Docket Number:	16-AAER-02
Project Title:	Appliance Efficiency Rulemaking for Computers, Computer Monitors, and Signage Displays
TN #:	214166
Document Title:	ITI - TechNet Comments on CEC Computers, Computer Monitors, and Signage Displays
Description:	N/A
Filer:	System
Organization:	ITI/TechNet
Submitter Role:	Public
Submission Date:	10/24/2016 4:51:49 PM
Docketed Date:	10/24/2016

ITI -TechNet Comments on CEC Computers, Computer Monitors, and Signage Displays (Docket #16-AAER-02)

**ITI/TechNet Comments on the Rulemaking
October 24, 2016**

Current Effective Dates

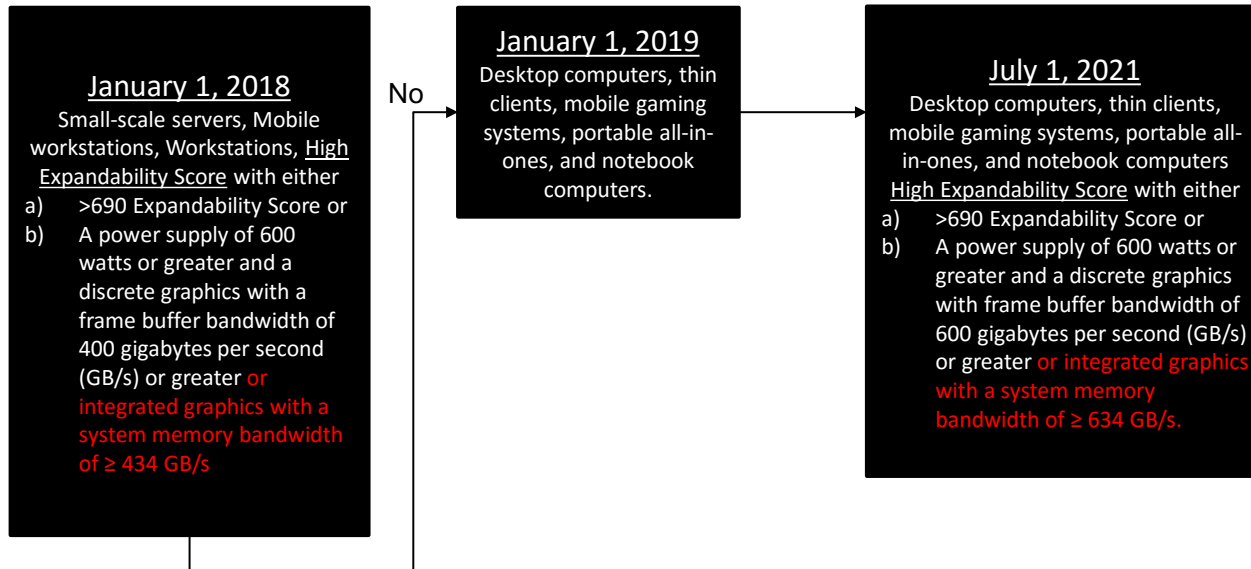
- **Schedule alignment:**
 - **Enhanced performance (EP) display dates:** EP Tier 1 and Tier 2 requirements are aligned with computer monitor effective dates (Table V-8). However, the same EP requirements apply to integrated desktop computers that have different effective dates. This date misalignment is confusing and unworkable for computers.
EP Industry Proposal: Modify Table V-8 to align EP requirements dates with computers effective dates respectively (Tier 1: Jan 1, 2019, and Tier 2: July 1, 2021). Please refer to proposed changes to the regulatory language in section 6 of this document.

Industry Proposed Effective Date Alignment
